# LVD Timing Diagram Correction

SPI-3R3 Figure 44 & 45 correction

Proposed changes to the LVD ST Timing Diagrams  
 -Figure 44

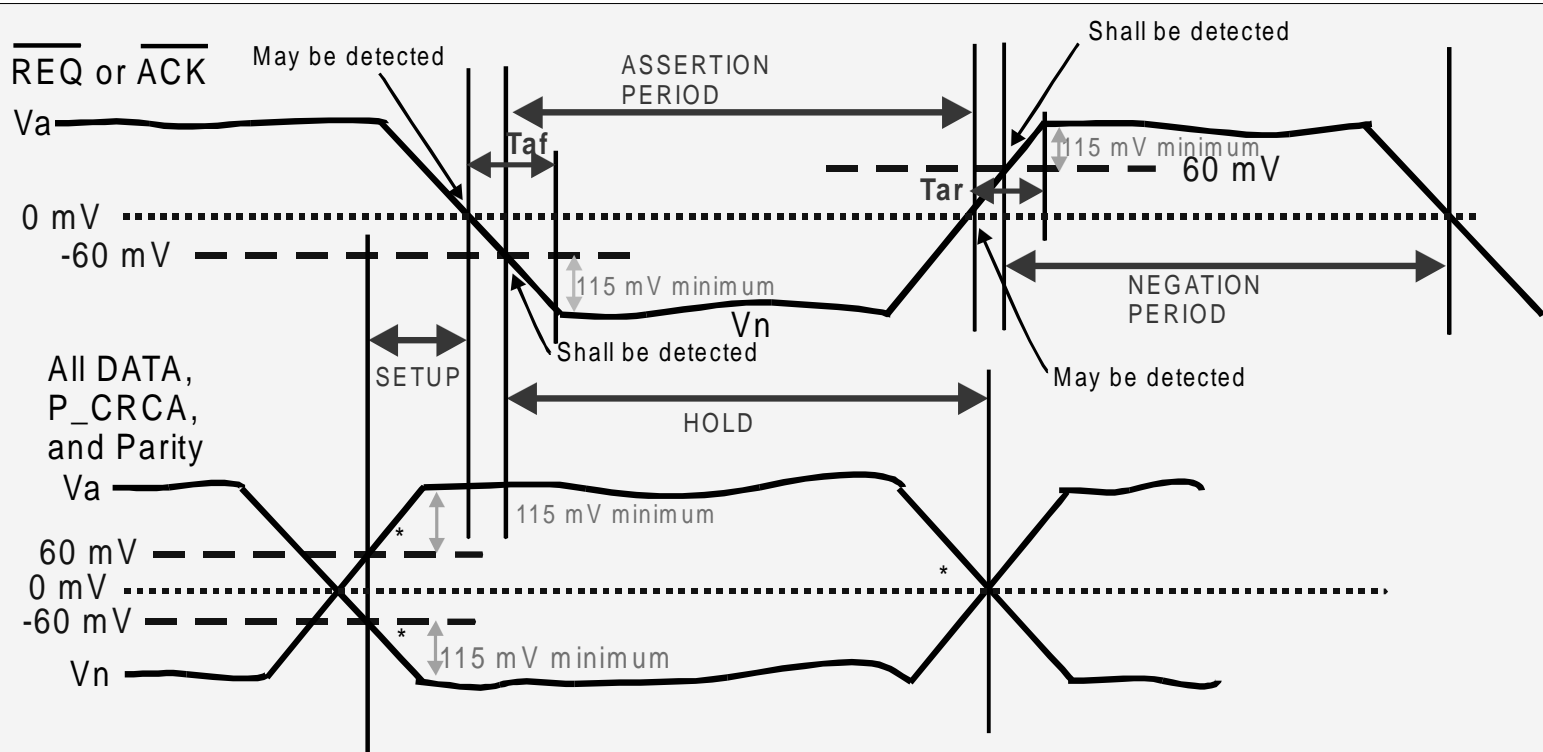
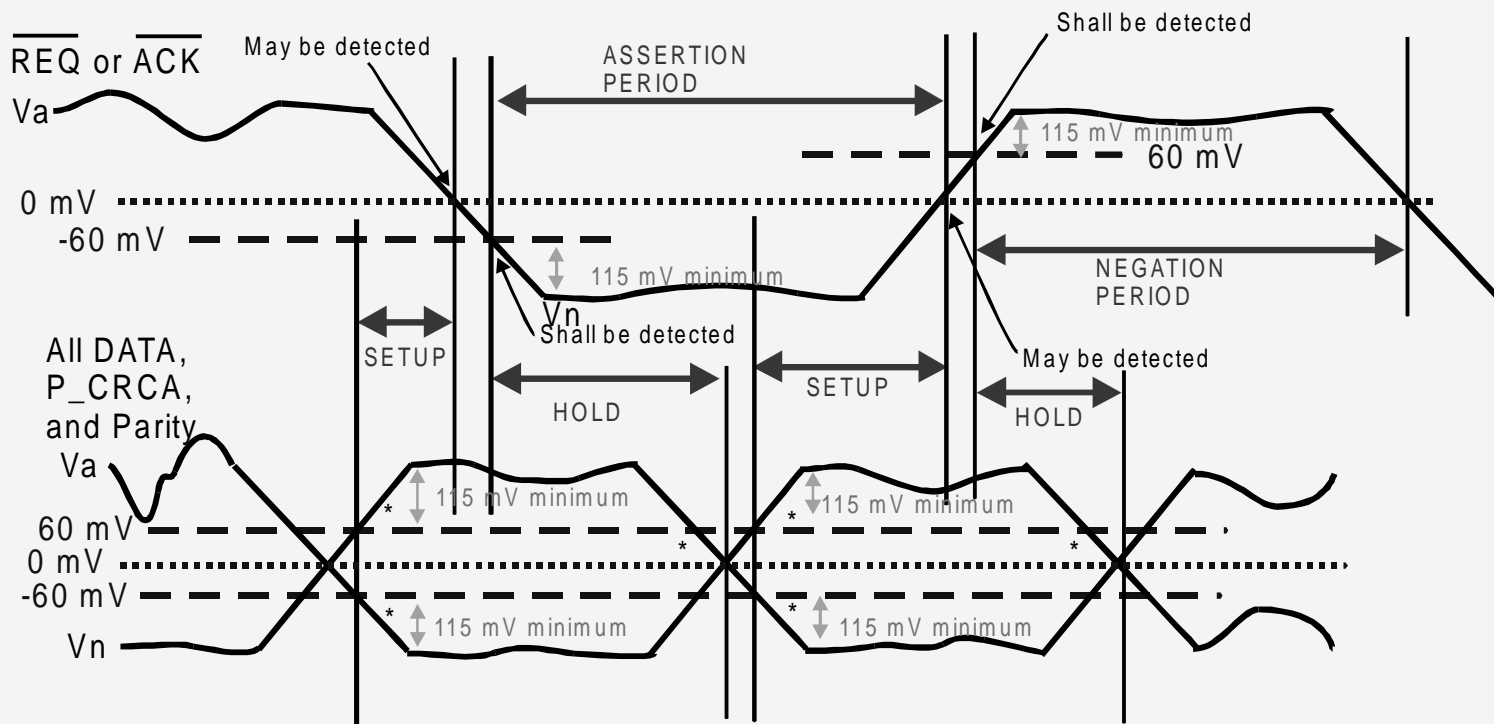
\* Use the crossing that yields the shorter SETUP and HOLD Time  
 $V_a$  or  $V_n$  must over drive the 60 mV threshold by 115 mV at the leading edge of the transition.  
 $V_n$  = Negated Signal  
 $V_a$  = Asserted signal  
 Differential voltage signals in all Cases

\* Use the crossing that yields the shorter SETUP and HOLD Time  
 $V_a$  or  $V_n$  must over drive the 60 mV threshold by 115 mV at the leading edge of the transition.  
 $V_n$  = Negated Signal  
 $V_a$  = Asserted signal  
 Differential voltage signals in all Cases  
 **$T_{af}$  and  $T_{ar}$  must be less than 5 ns and receiver will only see one transition even if there are signal reversals during the period.**

Proposed changes to the LVD DT Timing Diagrams  
 -Figure 45

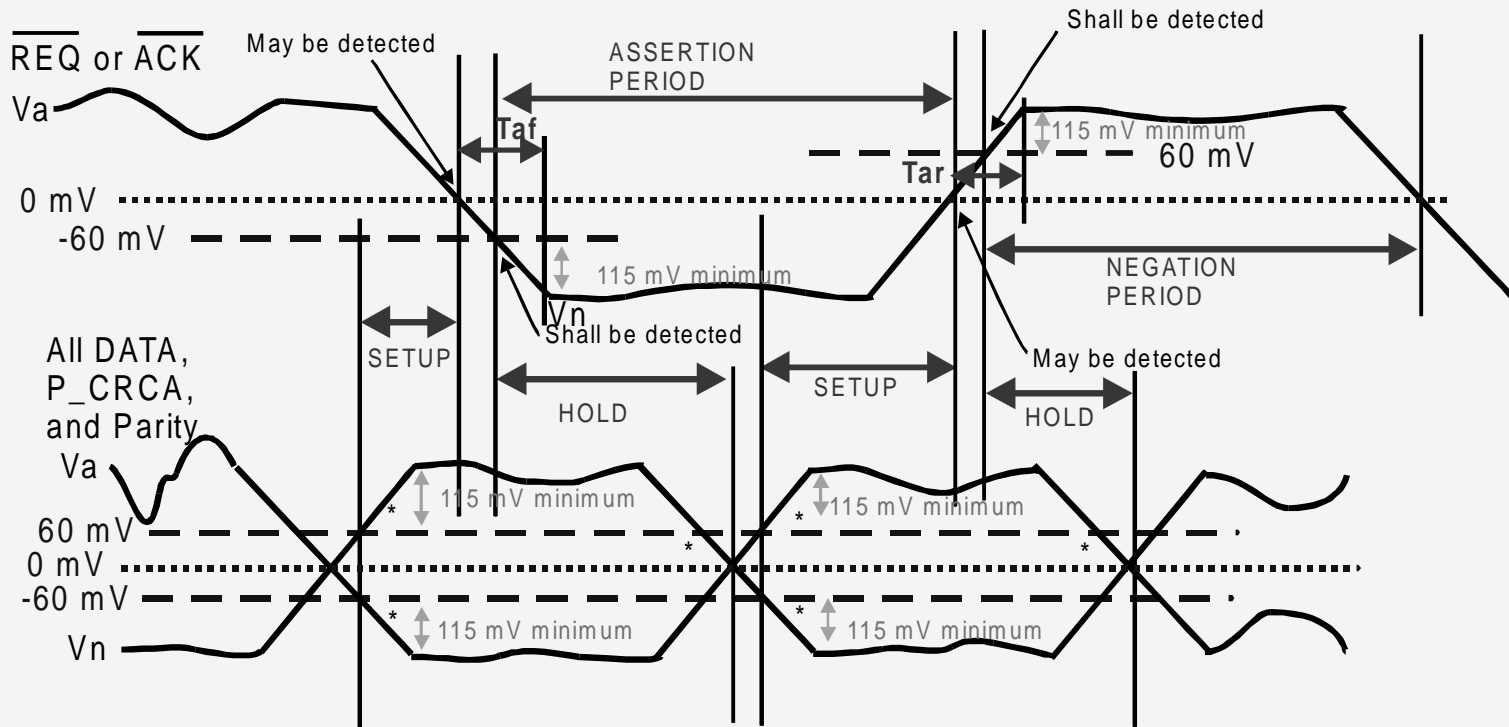
\* Use the crossing that yields the shorter SETUP and HOLD Time  
 $V_a$  or  $V_n$  must over drive the 60 mV threshold by 115 mV at the leading edge of the transition.  
 $V_n$  = Negated Signal  
 $V_a$  = Asserted Signal  
 Differential voltage signals in all Cases

\* Use the crossing that yields the shorter SETUP and HOLD Time  
 $V_a$  or  $V_n$  must over drive the 60 mV threshold by 115 mV at the leading edge of the transition.

**$T_{af}$  and  $T_{ar}$  must be less than 5 ns and receiver will only see one transition even if there are signal reversals during the period.**
